Application for Licence Amendment

Part V Division 3 of the *Environmental Protection Act 1986*

Licence Number	L8904/2015/1
Licence Holder	Cleanaway Solid Waste Pty Ltd
ACN	120 175 63
File Number	DER2015/001648
Premises	Banksia Road Putrescible Landfill Banksia Road CROOKED BROOK WA 6236 Lot 2 on Deposited Plan 65861 Certificate of Title Volume 1670 Folio 568 As depicted in Schedule 1 of L8904/2015/1
Date of Report	27 February 2023
Decision	Revised licence granted

Figure 1: Synthetic Cap Profile

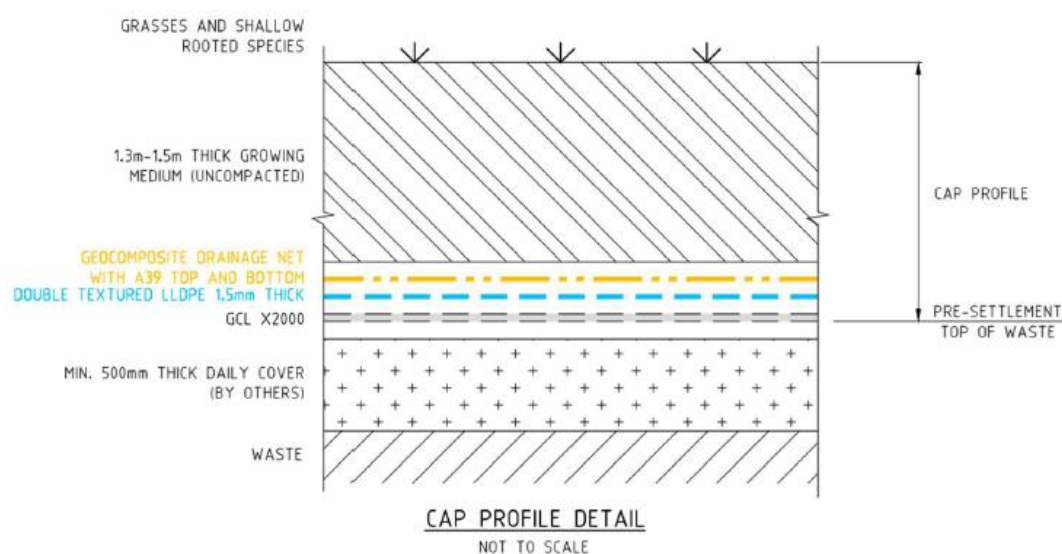
HELP modelling has determined that the designed leakage rate through the capping will be less than 0.001 mm/year, effectively preventing stormwater infiltration to the waste mass.

Questions related to how the leakage (infiltration) rate changes over time, concerns the application did not include a seepage rate and query regarding whether a target will be set for leachate	The proposed synthetic lining system of a GCL/LLDPE/Geocomposite drainage layer or sand drainage layer is an accepted landfill capping system for limiting the possible infiltration rate through the cap liner to less than 75% the landfill base liner (GCL/HDPE lining system). This infiltration rate is not expected to reduce over time.

Summary of Stakeholder's comment	Department's response
generation.	The seepage rate has been modelled as effectively zero seepage for the life of the capping layer. This was included within the application documentation. There is no target set for leachate generation as the expected outcome of the capping is to reduce the leachate generated in the waste mass to effectively zero over time. Leachate management is a condition of the licence, and the installation of a leachate reticulation system further ensures that leachate will not overflow as it is being redirected into the landfill cell.
Query regarding how the seepage rate of the capping has been set due to the variety of liners, and whether the proposed seepage rate is appropriate.	The proposed design for the capping liner is consistent across the proposal and is considered one of the highest standards available for landfill liner configuration. The capping infiltration rate has been designed to be at least 75% of that of the base liner, but in many areas of the landfill it will exceed this due to the variety of the basal liners, effectively achieving 150% of the liner in some instances.

Figure 3: Leachate reticulation design

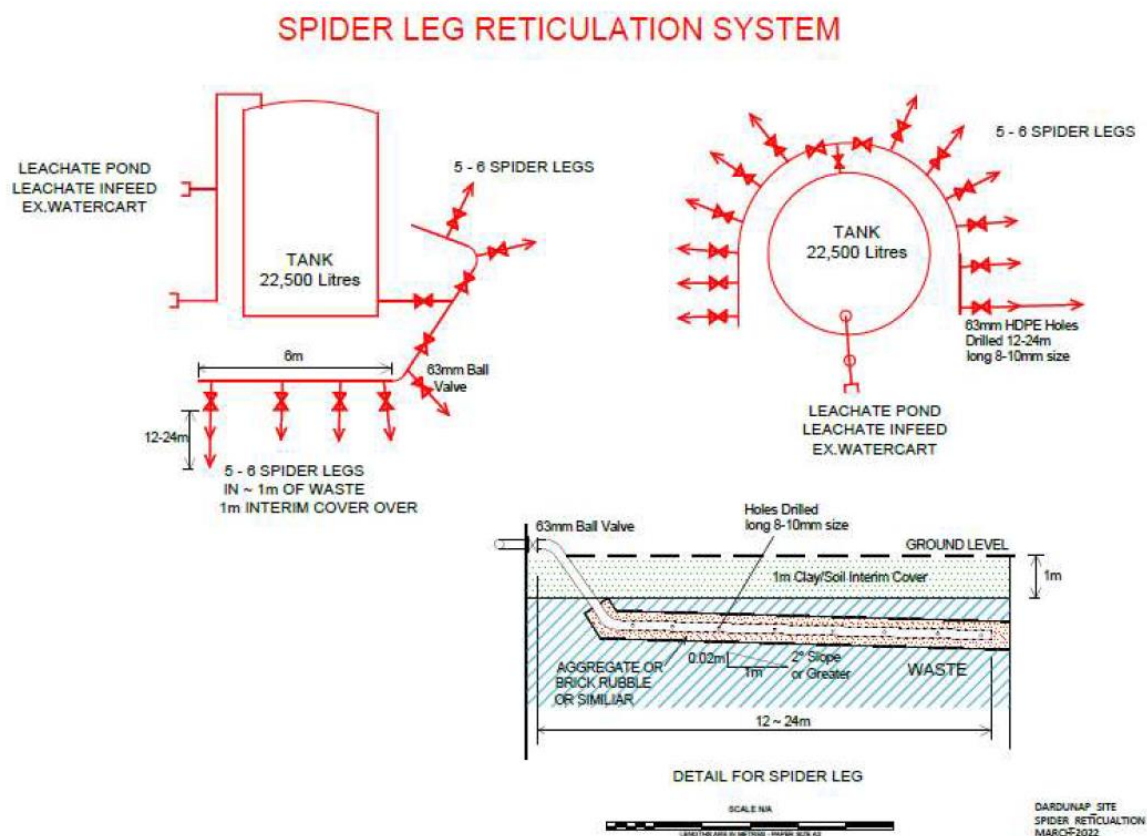
Consultation method	Comments received	Department response
Application advertised on the department's website (7/11/2022)	Refer to Appendix 1	
Local Government Authority advised of proposal (9/11/2022)	The Shire advised they have no comment, aside from noting that the tanks associated with the leachate reticulation may require development approval from the Shire.	Noted. Nothing in the amended licence removes the requirement to obtain other relevant approvals.
Application referred to Department of Biodiversity, Conservation and Attractions (9/11/2022)	No comments received.	Noted.
Application referred to all stakeholders on DWER's register of stakeholders for this premises (9/11/2022)	Refer to Appendix 1	
Works Approval/Licence Holder was provided with draft amendment on (15/02/2023)	No comments, updated as built gas infrastructure plan provided.	Noted. Plan 3 updated with provided as built diagram. Previous Plan 4 removed as all items are now included in Plan 3. Previous Plans 5 to 7 renamed 4 to 6 and relevant conditions amended.

Appendix 2: Rehabilitation Staging Plan

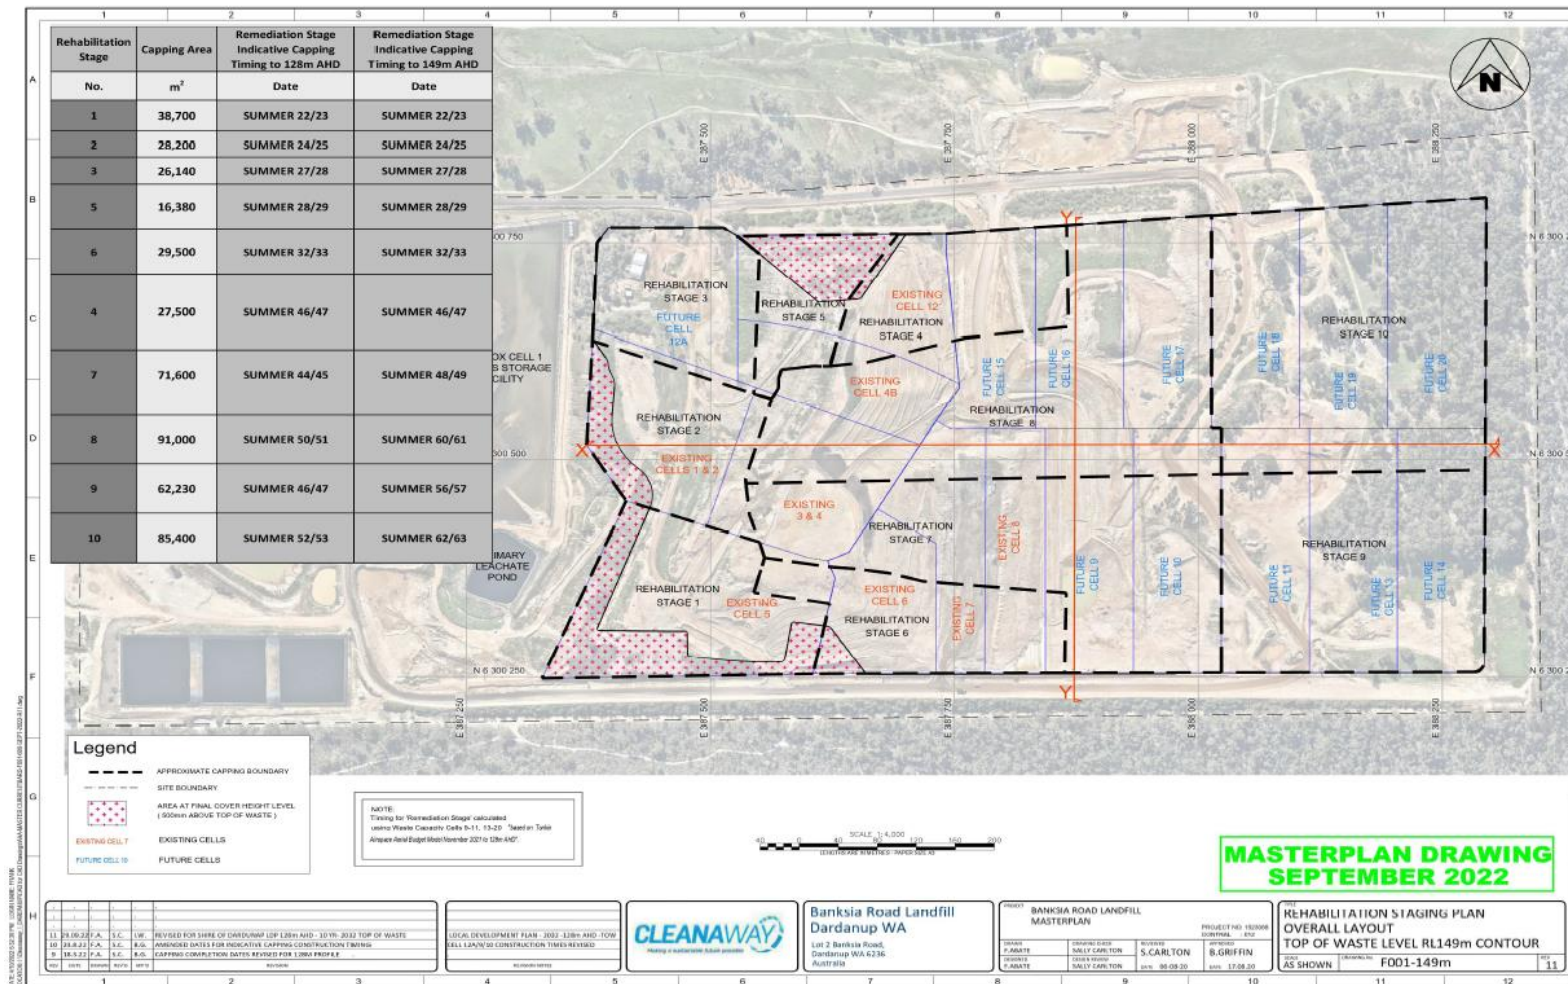
Plan 6	Plan 6 has been added to demonstrate the rehabilitation stages.
